SUBJECT: Forwards interpretation of processed data re marine seismic investigation conducted during Jul 1981. Changes to FSAR resulting from interpretation of data will be included in Amend 10 of FSAR.

Re: St. Lucie Unit No. 2  
Docket No. 50-389  
Marine Seismic Investigation  
Interpretation of Processed Data

Insert "A" to St. Lucie Unit 2 FSAR

Pages 2.5-40 and 2.5-40a

FIGURE 2.5-42p

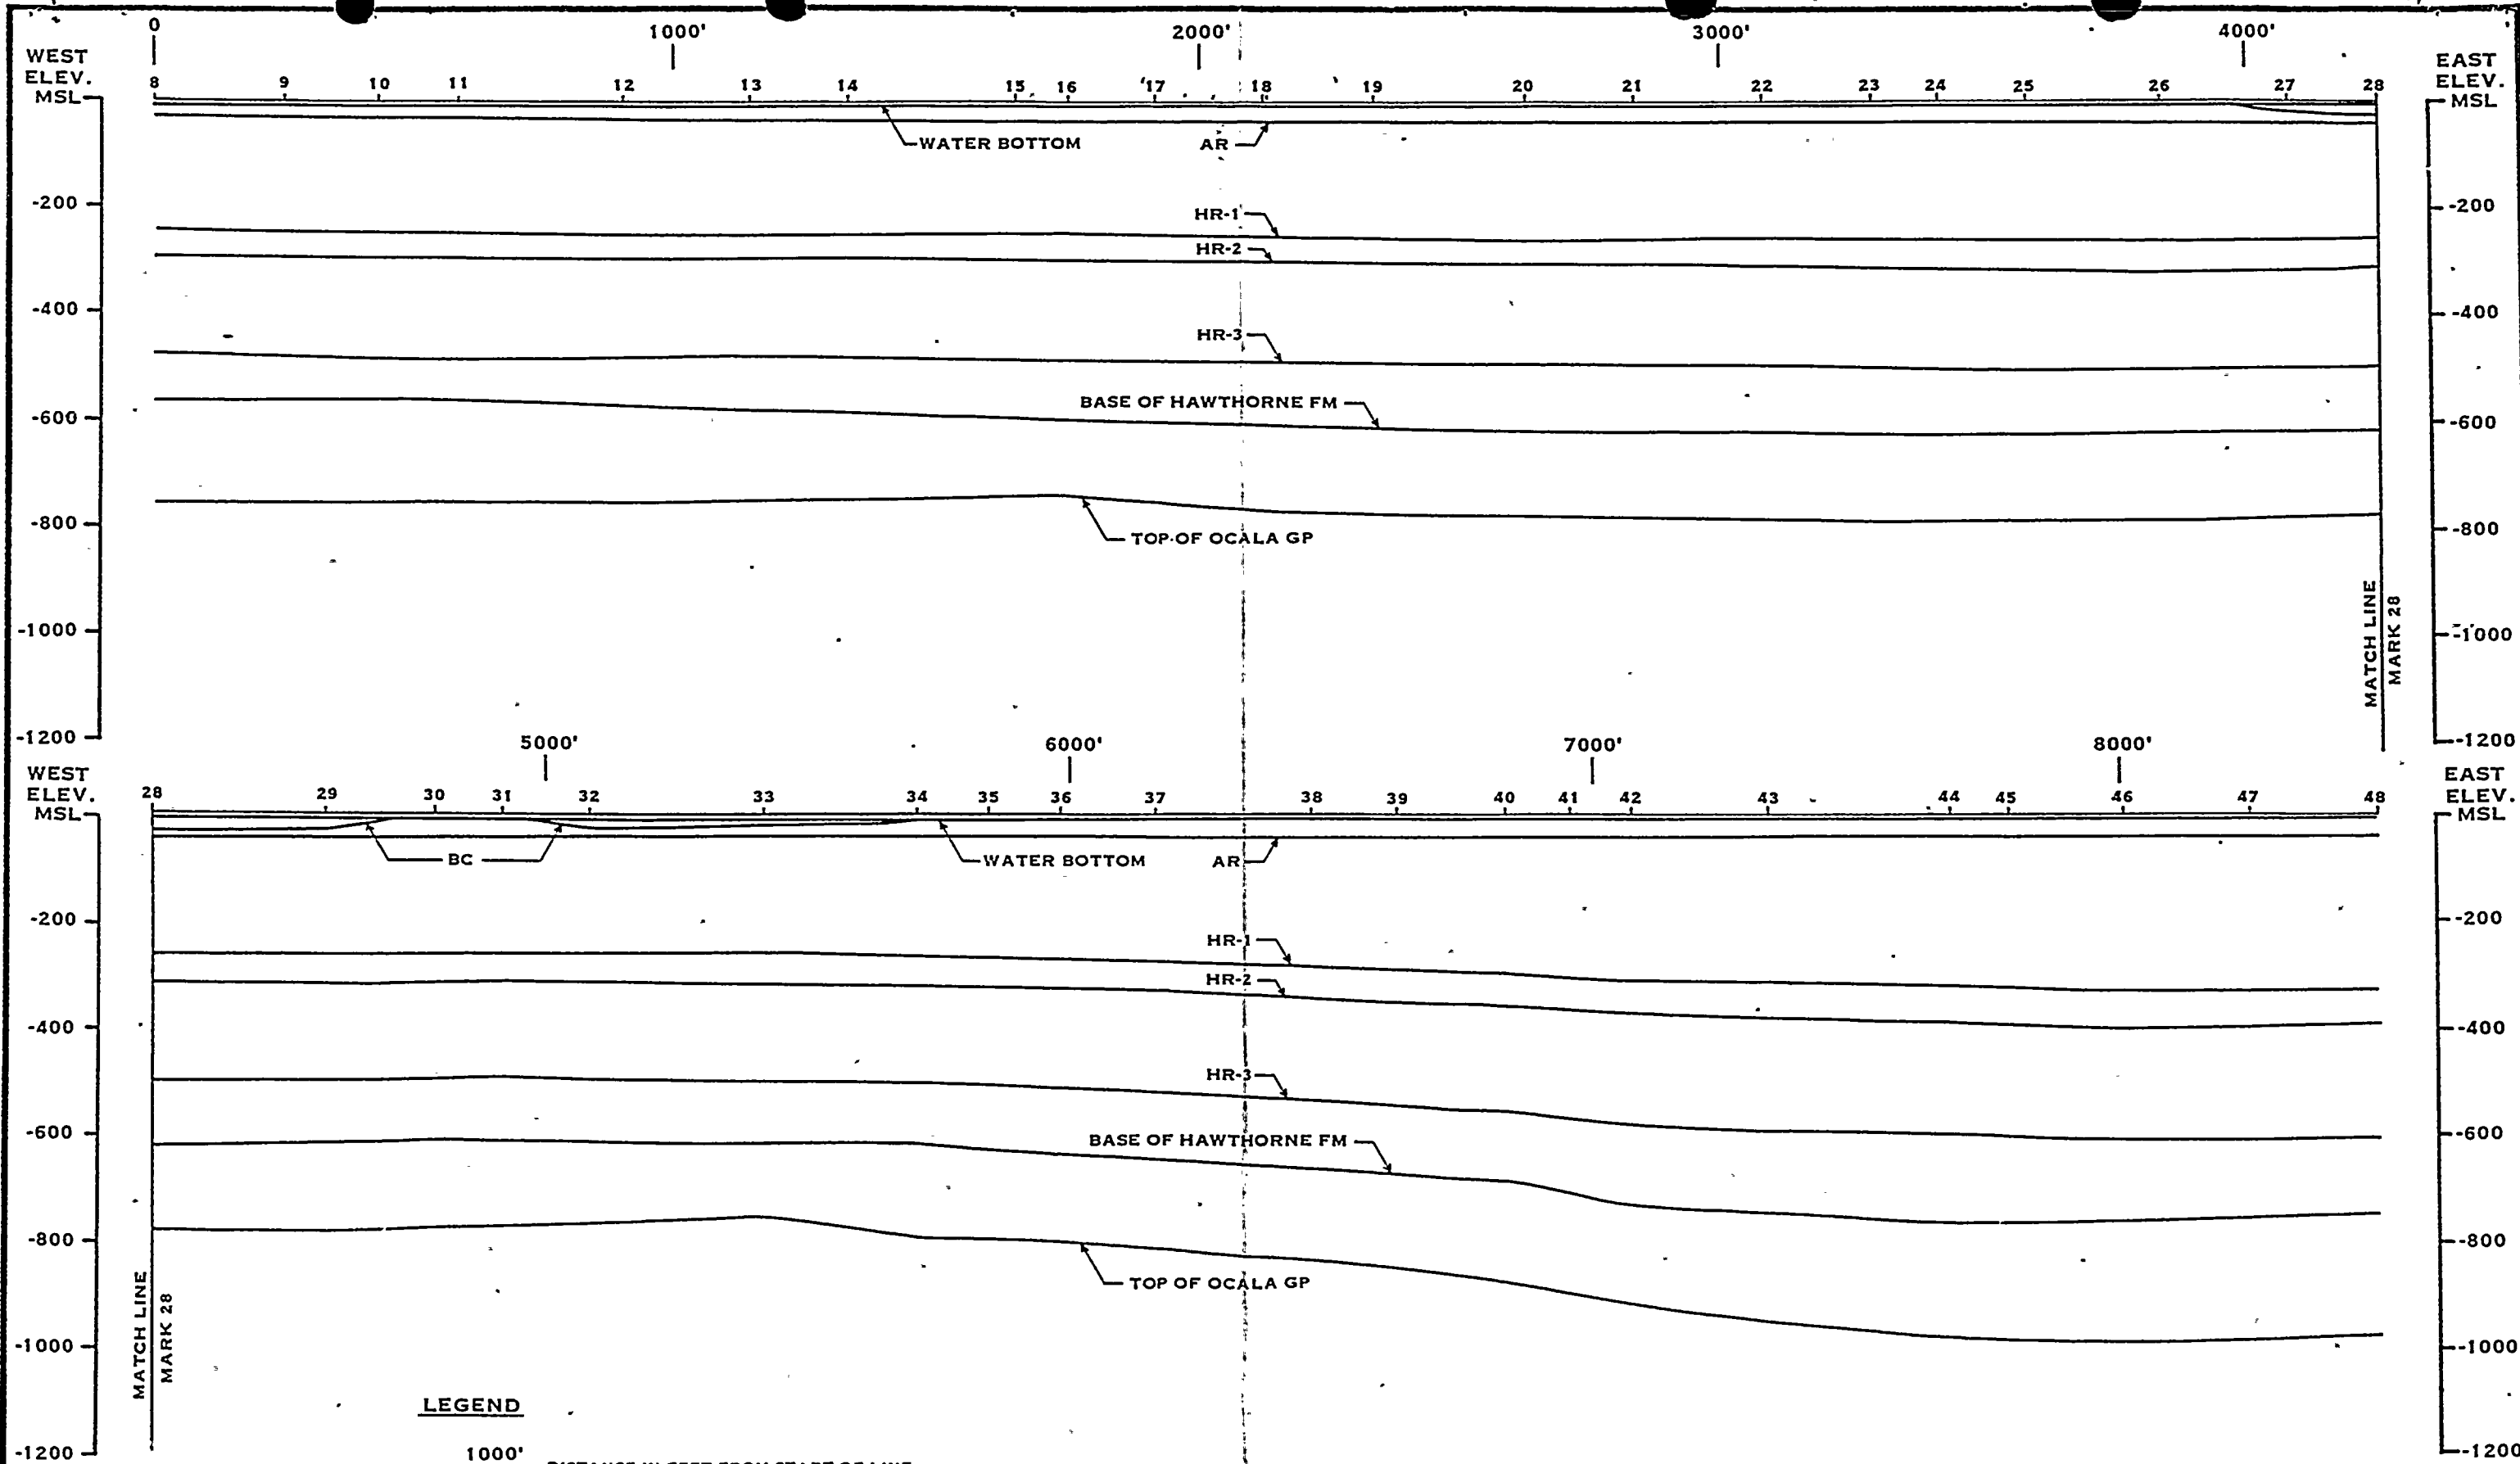
~~These are most apparent on lines 2, 3, 5 and 6(B) (Figures 2.5-42p, 2.5-42q, 2.5-42u and 2.5-42w. The dip of the upper horizons (base of Hawthorne Formation and above) on these features averages 150 ft. per mile~~

~~but increases to over 400 ft. per mile on line 2 and line 6(B). The top of the Ocala Group generally has a steeper dip than the overlying horizons (Figures 2.5-42p, 2.5-42q, 2.5-42u and 2.5-42w, and reaches about 550 to 850 ft. per mile on lines 2 and 6(B) (Figures 2.5-42p and 2.5-42w).~~

These flexures are most apparent on lines 2, 3, and 6(b) (Figures 2.5-42p, q, and w). The apparent dip of the base of the Hawthorne Formation averages about 59 feet per mile and ranges from over 400 to nearly 1,000 feet per mile at certain points along lines 2, 3, 4 and 9 (Figures 2.5-42p, q, s and aa). The apparent dip of the top of the Ocala Group, which is generally steeper than the dips of the overlying horizons, averages about 123 feet per mile but reaches over 1,000 feet per mile on lines 2 and 9 (Figures 2.5-42p and aa).
